SERVICE ADVISORY # 15-225**Norco Cable Bracket**

It has been determined the below listed Indiana production vehicles were manufactured with cable bracket fasteners that may break. This advisory explains how to replace the fasteners.

Fig. 1

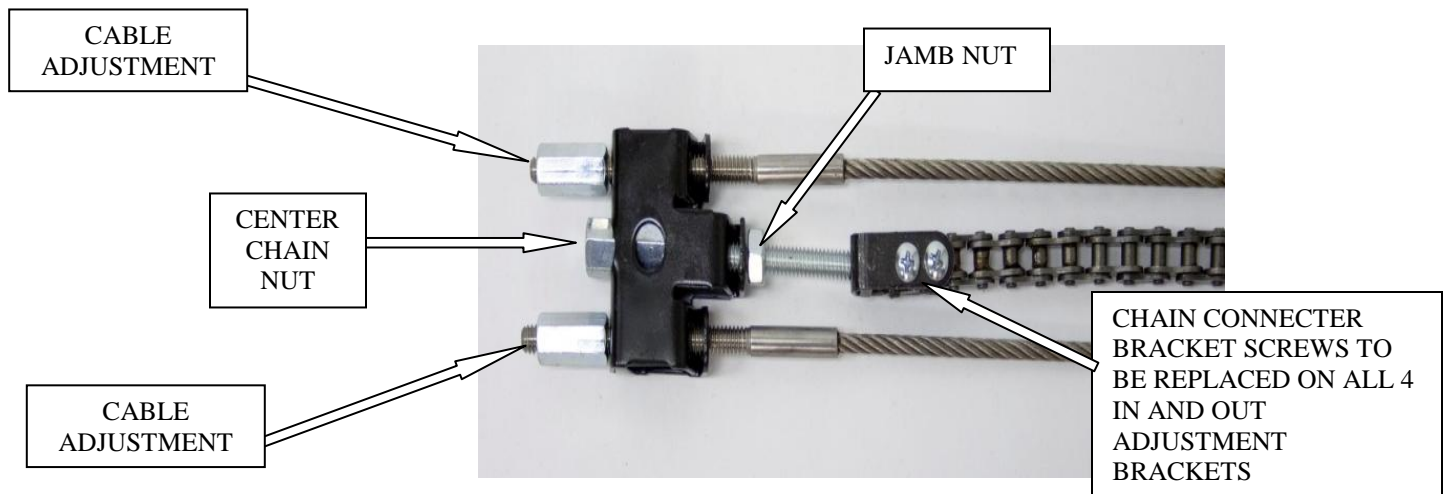
- Step 1** Locate the trailer on a level, flat and hard surface. Chock the wheels.
- Step 2** Extend the slide room to the out position. From the exterior, properly support the room.
- Step 3** Using standard industry practices, remove the interior slide room fascia to gain access to the cable adjustment brackets.
- Step 4** Loosen all center chain nuts (all 4 in and out adjustment brackets), leaving the jamb nuts and cable adjustment nuts in place. See Figure 1.

CHAIN
CONNECTOR
BRACKET

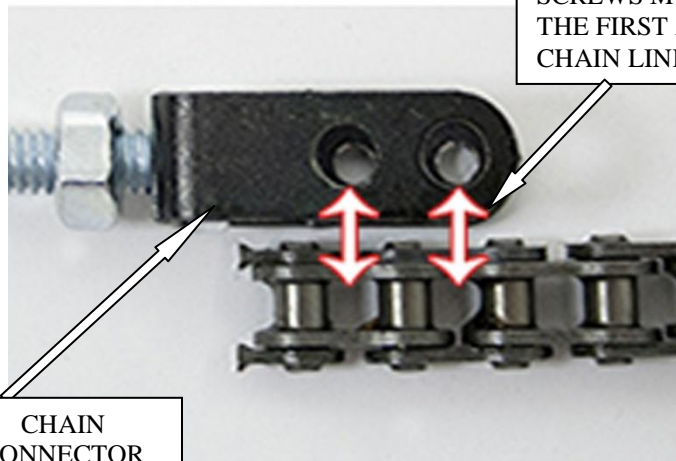
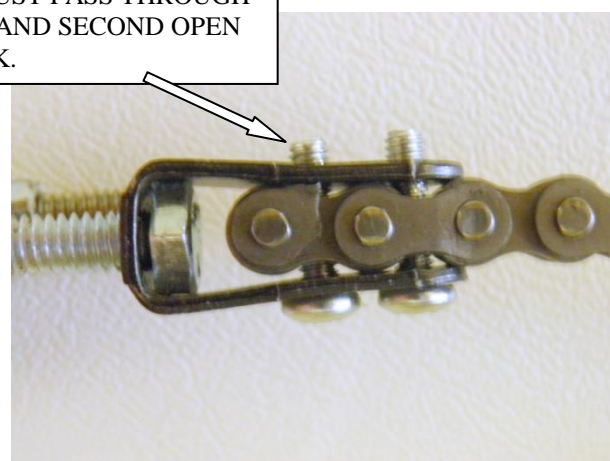
- Step 5** At the chain connector bracket, remove one screw at a time and replace it with a new screw. If the bracket is damaged or bent, take a picture of the bracket, remove the chain nut and replace with the supplied chain connector bracket. See figure 2 & 3. Tighten both the screws. Repeat the screw replacement for both screws of all 4 chain connector brackets.

IMPORTANT:
WHEN REPLACING CHAIN
CONNECTER SCREWS, BOTH
SCREWS MUST PASS THROUGH
THE FIRST AND SECOND OPEN
CHAIN LINK.
